Air Resources Board

Vapor Recovery Compliance Test Procedure

TP-201.1B

Static Torque of Rotatable Phase I Adaptors

Figure 2
Static Torque Test Assembly

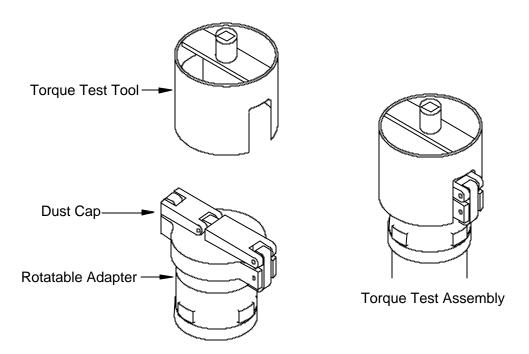
5.2
- 5.25.2 Static Torque Test Assembly. Use a compatible dust cap and rotatable adaptor Torque Test Tool, Phil-Tite® Part Number 6004 or equivalent. A depiction of the Phil-Tite® Torque Test Tool of a Torque Test Tool is shown in Figure 1. An example of acomplete Static Torque Test Assembly is shown in Figure 2.

- **7.1** Install the dust cap on the Phase I rotatable adaptor.
- **7.37.2** Install the Torque Test Tool on the dust cap as shown in Figure 2.
- <u>7.3</u> Verification of rotation, <u>This test is</u> conducted prior to the <u>Sstatic Ttorque Ttest.Static Torque Test.</u> Place a socket wrench with socket extension (if required <u>needed</u>) into the Torque Test Tool, or equivalent. Rotate the adaptor a minimum of 360 degrees. <u>Note:</u> <u>deDo</u> not continue <u>with static torque measurements</u> if the adaptor does not rotate 360 <u>degrees.</u> <u>degrees.</u> <u>Record the result on the data sheet where provided.</u>
